Warranty Bulletin

WB25-83A

Revision: A	Addition of part No. for serial cable	06-20-2025

HVAC SOFTWARE UPDATE TO RESOLVE HEATING ISSUES 9700 (B13R)

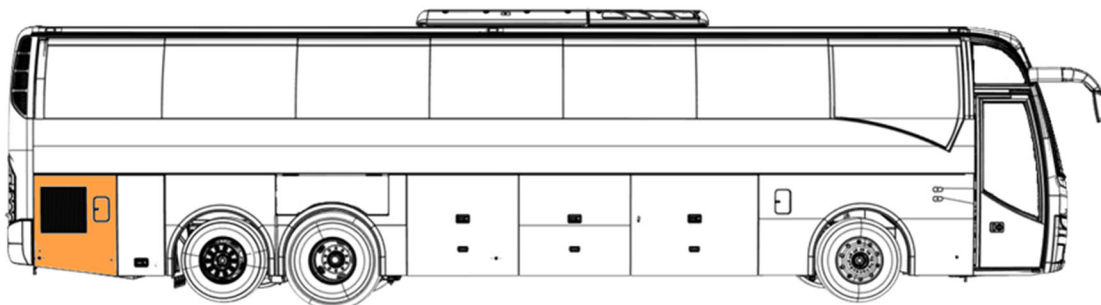
1.   Open the auxiliary heater service door.

2.   Locate the coolant temperature sensor.

3.   Cut the cable-tie and disconnect the sensor from the electrical harness B21. Remove and discard the sensor.

4.   Insulate the harness terminals using heat shrink tape and stow the branch securely within the nearest harnesses.

MCM (Master Control Module) service switch.

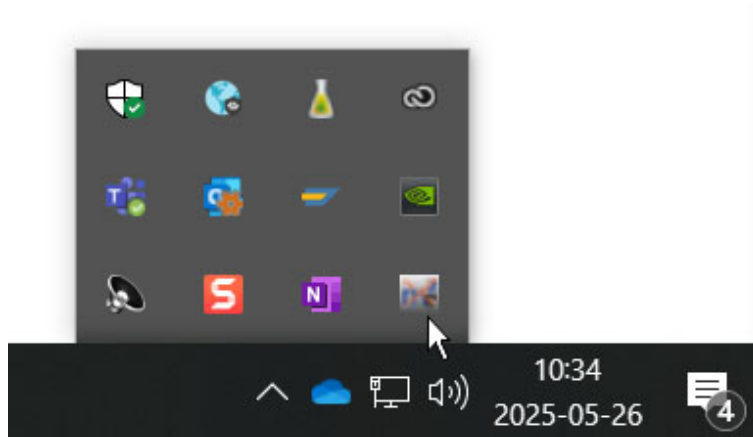
3. Activate the MCM service switch in the electrical compartment.
